1966 Corvette: Product Data Book: Radiator Grille Supports

Source: Technical Service Department - Product Data Book

Date: March 22, 1966

FIGURE 1

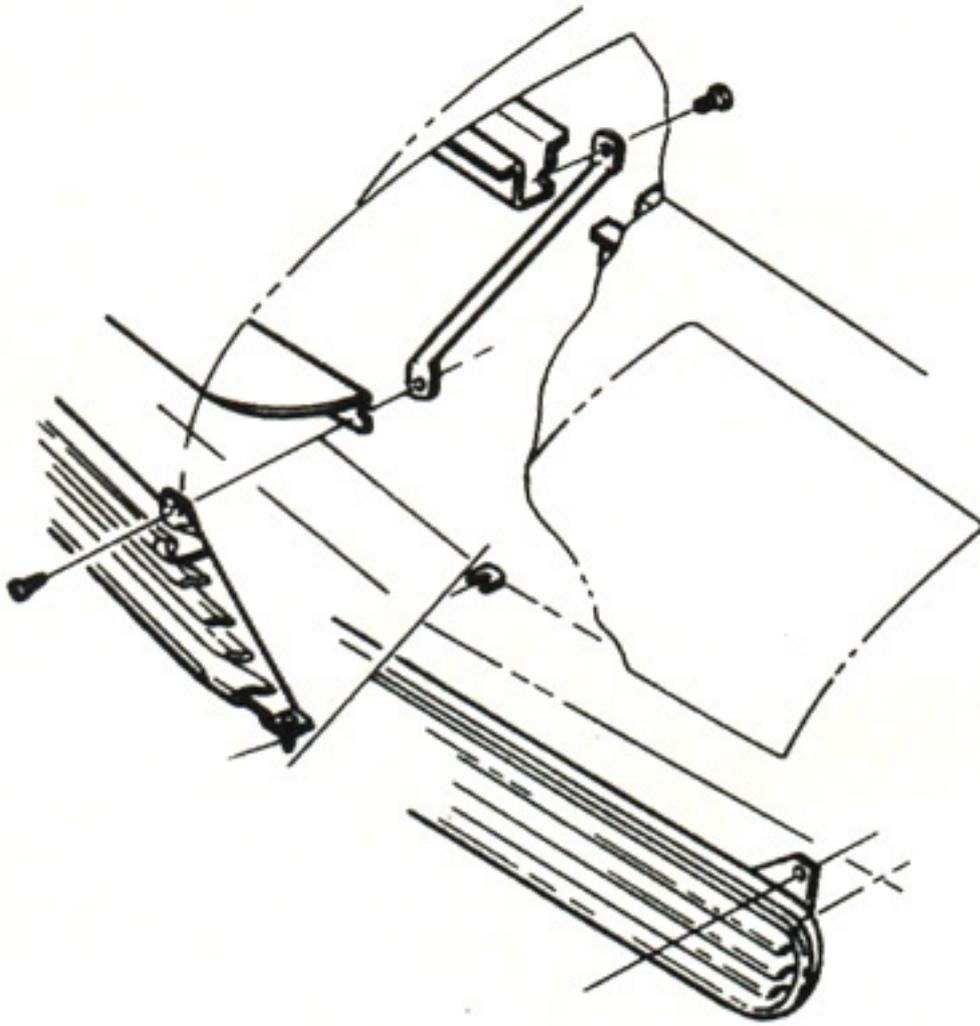
When 1966 Corvettes are driven on rough surface roads, there is a possibility the outer grille supports may break at the body attaching locations.

In production, starting with serial #S115499, the radiator grille supports are of an improved design and a radiator support rod has been added at the center. This is similar to 1965 production.

If outer grille support breakage is encountered on vehicles built prior to serial #S115499, install radiator grille supports, Part No. 3897389, and center radiator support rod, Part No. 3897387. (fig. 1).
